**Engineering Services March 21, 2017  
Preliminary Drainage Observations  
Memorandum**

To: Sean Trippi Planning Division	From: Patrick Ryan Engineering Services
Date: March 21, 2017	Re: P15-00215 – WHL Winery Preliminary Drainage Observations APN: 027-460-013

**P15-00215 - WHL Winery**  
Site Drainage Conditions.

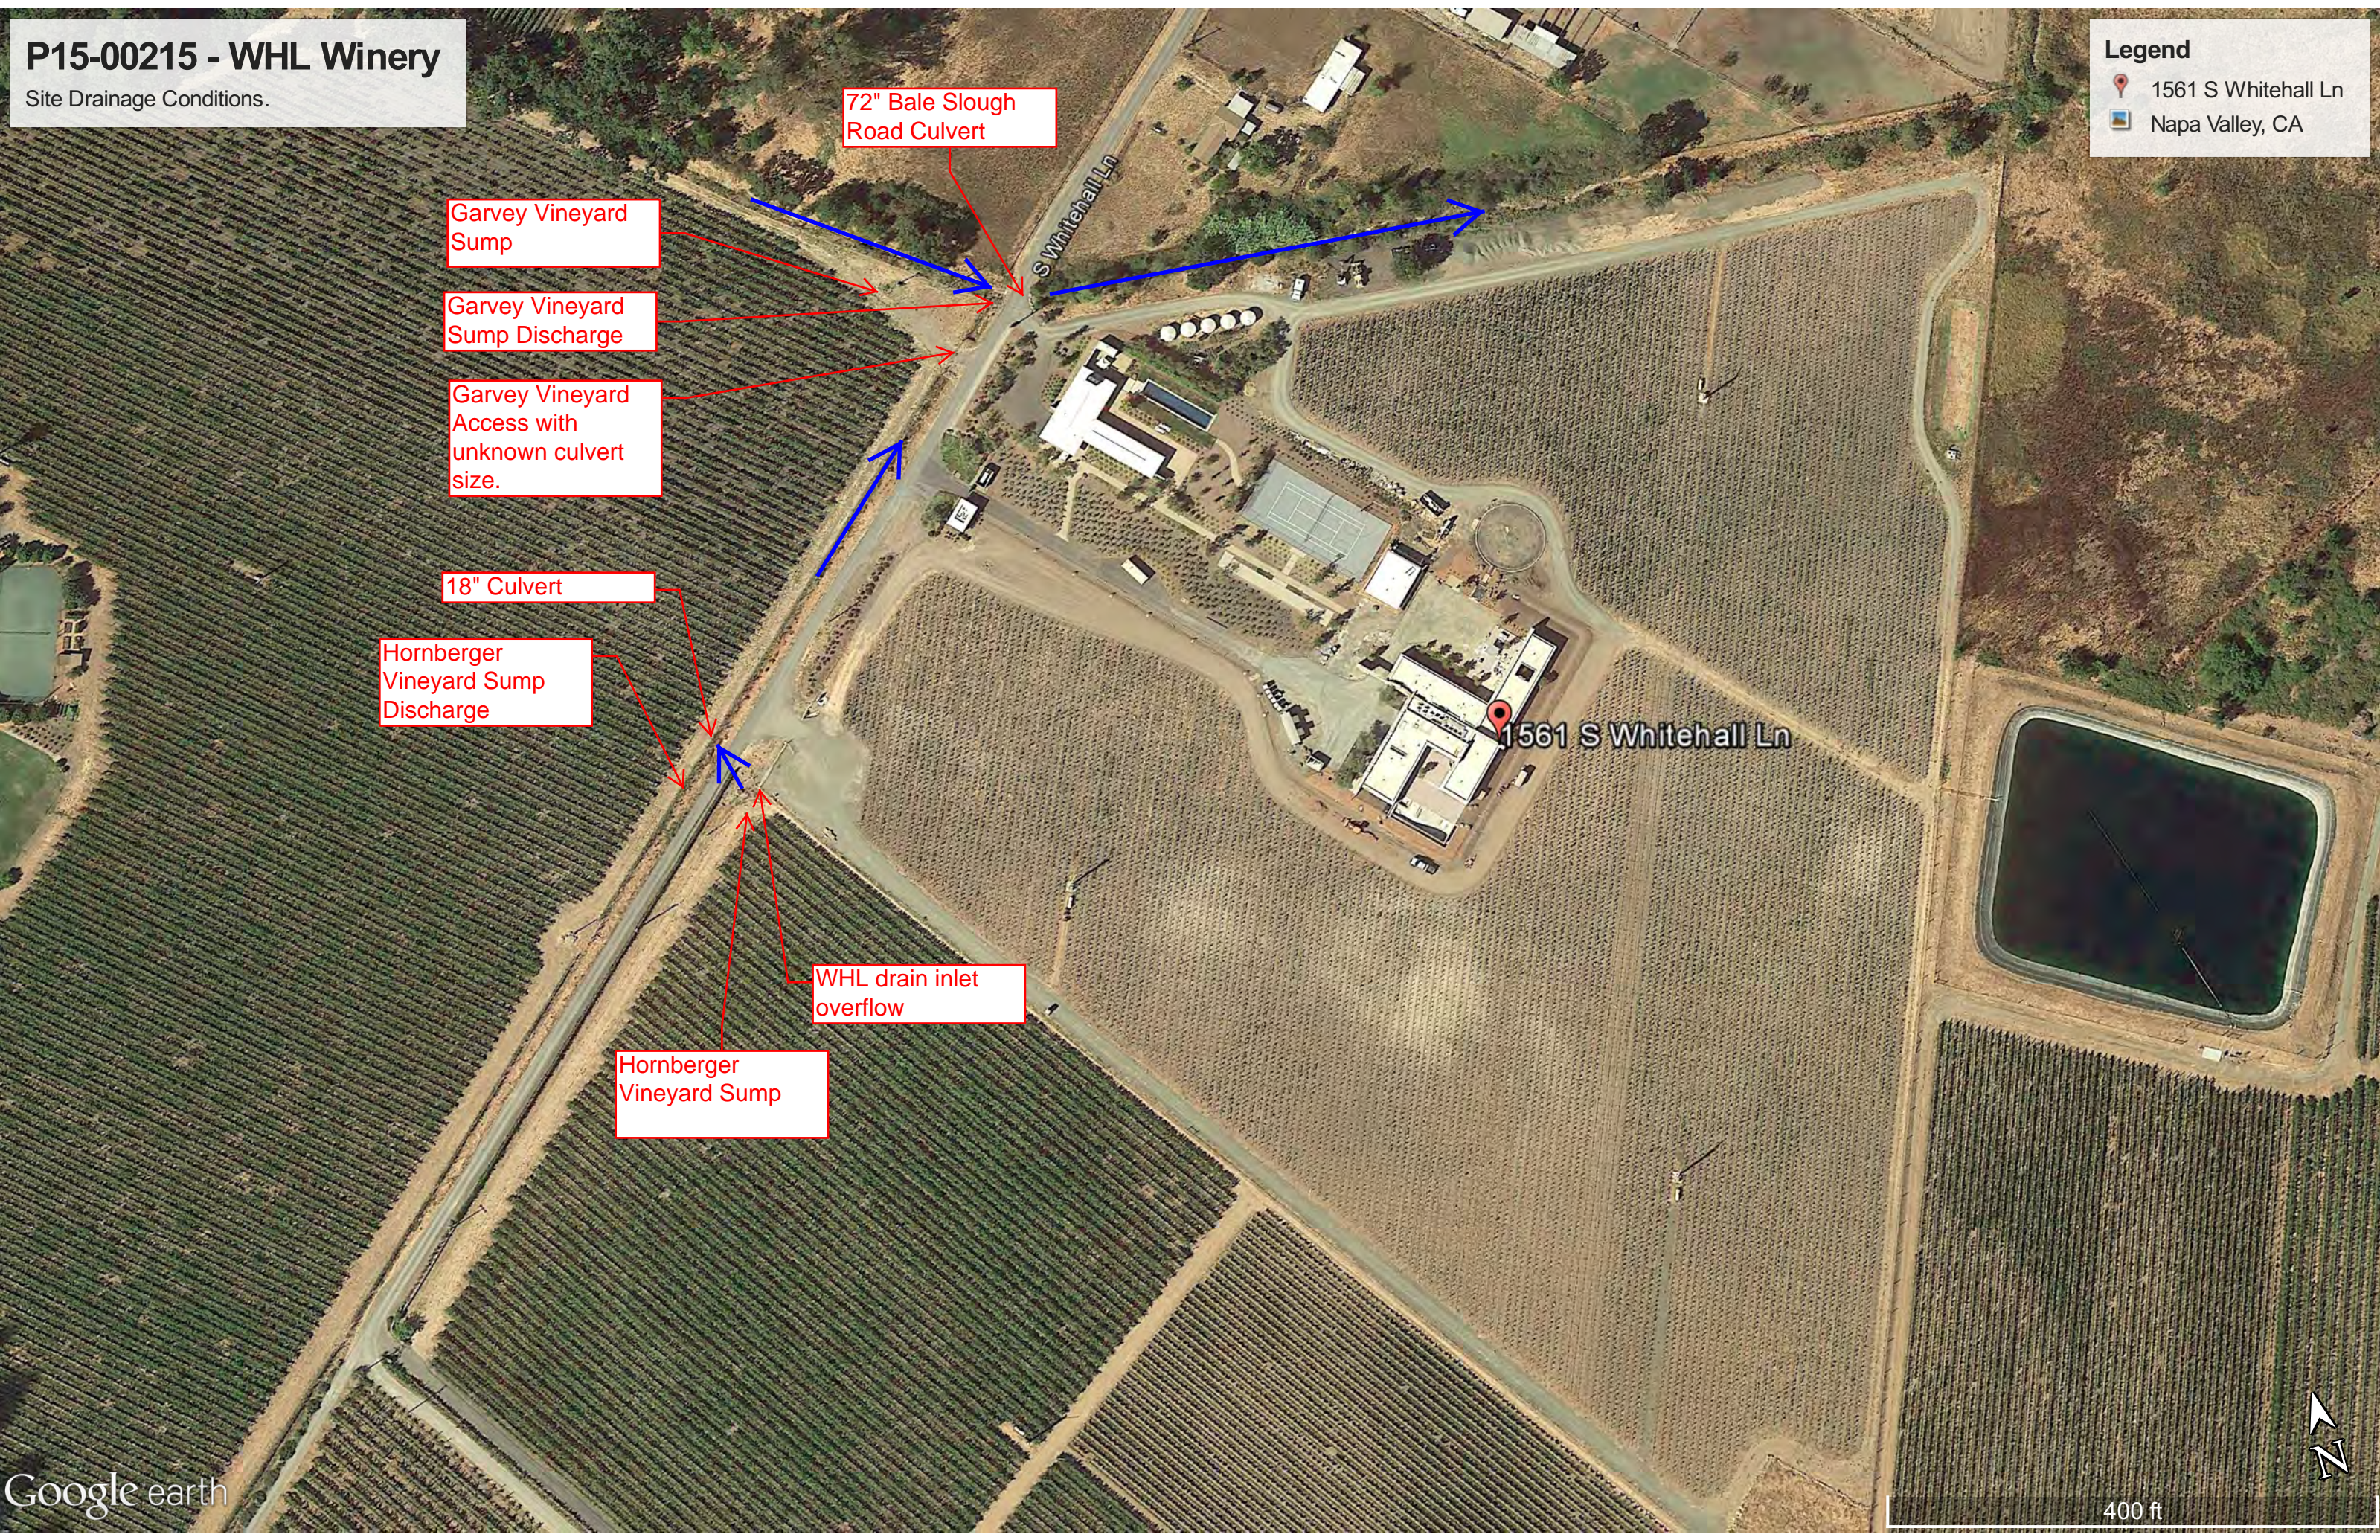
Runoff from the contributing watershed conveys via surface flows along natural drainage patterns and artificial conveyance systems including a drainage swale along the south side of S. Whitehall Lane, a roadside ditch on the north side of S. Whitehall Lane before entering Bale Slough, just upstream of an existing 72” corrugated metal pipe (CMP) culvert. In addition to the surface flows entering the road side ditch, two vineyard sump discharge pipes were observed being discharged in the stormwater conveyance system. A vineyard sump from the Hornberger vineyard development (APN: 027-460-016) discharges into the road side ditch west of the proposed WHL Winery access road and a vineyard sump from the Garvey vineyard development (APN: 027-460-036) discharges directly into Bale Slough at the upstream side of the existing 72” CMP culvert (see exhibit attached for site map).

The 72" CMP under S. Whitehall Lane is half silted providing limited conveyance capacity of the channel, which contributes to a backwater condition within Bale Slough (upstream of the CMP culvert) and the roadside ditch along the north side of S. Whitehall Lane. Backwater is caused when an obstruction, such as a pipe constriction, in a downstream condition raises the upstream water surface elevation. In addition to the limited carrying capacity of the Bale Slough culvert additional evaluation of the vineyard road culvert at the Garvey property (APN: 027-460-036) and its conveyance capacity is needed to determine if it is acting as a channel restriction.

Engineering recommends that the affected property owners and/or concerned neighbors work together on a solution in conjunction with obtaining the appropriate permits from County of Napa Planning, Building and Environmental Services (PBES) Department and Department of Fish and Wildlife to remove the silt and maintaining the existing roadside ditch and 72-inch culvert within Bale Slough.
